ZBA Submission Revisions

PROJECT: McQuade Residence
125 East George Avenue
Pearl River, NY 10965
Town of Orangetown

DESCRIPTION OF REVISIONS:

SHEET NUMBER:
A-100.00

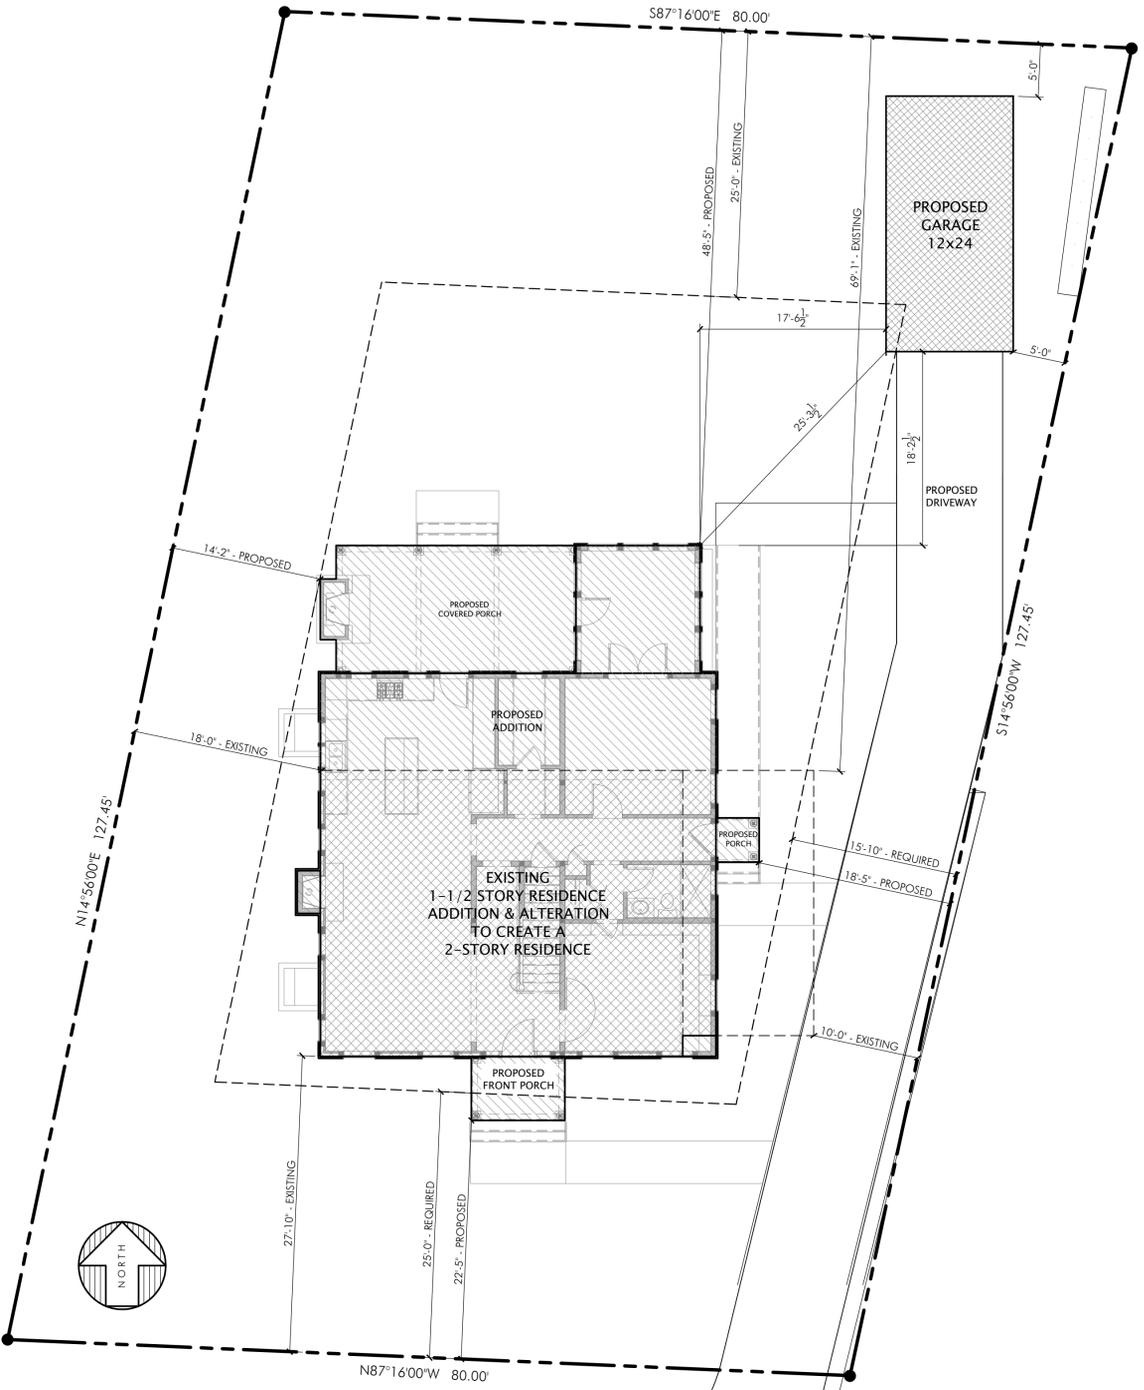
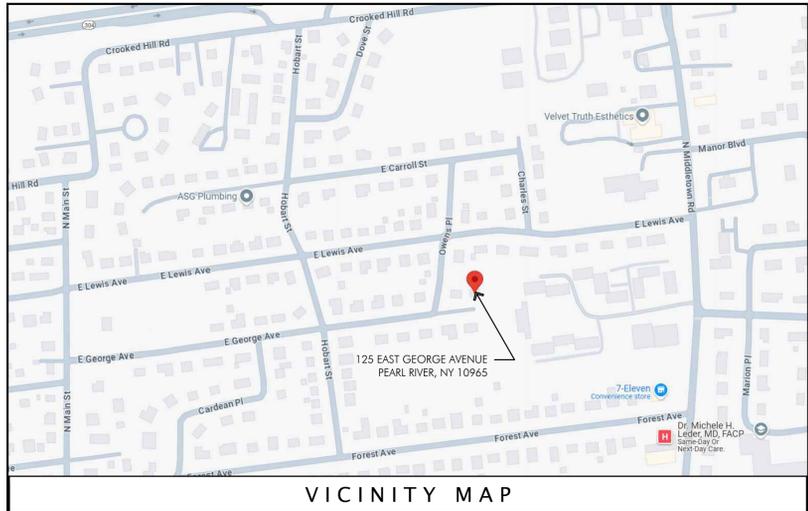
- FAR Reduced from 41.20% to 35.98%
 - First & Second Floor reduced from 3,272 s.f. to 2,949 s.f.
 - Front Porch reduced from 230 s.f. to 53 s.f.
 - Side Porch reduced from 20 s.f. to 16 s.f.
 - Rear Porch reduced from 316 s.f. to 280 s.f.
- Front Yard Set-Back increased from 21'-10 1/2" to 22'-5"
- Combined Side Yard Set-Back increased from 30'-0" to 32'-7"
- Building Height reduced from 26'-6" to 25'-8"
